TECHNICAL MEMORANDUM

DIAGNOSTIC STUDIES OF HIGHWAY VISUAL COMMUNICATION SYSTEMS

PILOT SITE NUMBER 4

CALIFORNIA STATE HIGHWAY 1 NEWPORT - CORONA DEL MAR, CALIFORNIA

STRIP MAP OF STUDY SITE 4 INDICATING DRIVING ROUTES
 FIGURE 1

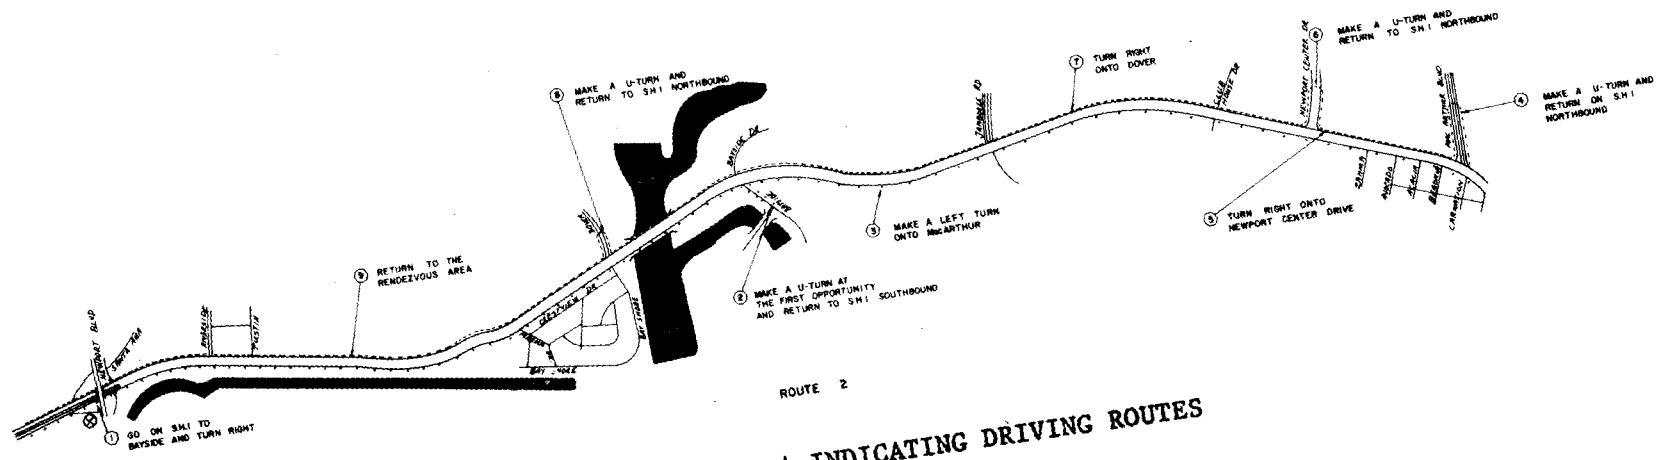
The team identified several design problems which were of concern to them. The inconsistency in design seemed to be of the greatest concern. The section varied from no curb and no shoulder to full curb and gutter and back again. The lack of consistency in the design continually surprised the subject drivers. The deep ditches adjacent to the roadway in the dunes area was of concern. The only indication of a ditch was a periodic delineator.

The location of utility poles within four feet of the traveled-road was recognized as a major concern. Also, there were several trees located within the shoulder area. The composite average clear distance from the edge of the traveled-way without a curb was 17.8 feet.

The major design changes suggested by the team (i.e. bridge widening) had already been undertaken prior to the study. The approach to the structure should be outlined with post-mounted delineation tapered gently into the bridge.

Signing - The primary signing problem was the street name problem. It was suggested by the team that advance street name signing be added to each major intersection. Due to the interference from the roadside development, this signing should be median mounted or mounted overhead. When the overhead installation is used, external illumination is required in order to insure good visibility. Where roadside development is not a problem, the advance notice can be placed on the right 400 to 500 feet in advance of the intersection.

Several of the diagnostic team members felt that an edge stripe in the uncurbed sections of the study would be effective and recommended that a continuous edge stripe be used in these areas. Also, a special wide edge stripe (10" - 12") on a very flat taper was recommended for the bridge over Newport Bay.

Delineation - The power poles located very near the throughway should be moved if possible and more adequately delineated until this can be accomplished. Spot replacement of reflective material on the poles should be dropped in favor of a complete replacement of all reflective material at one time, in order to maintain the same level of reflectivity on all obstructions.
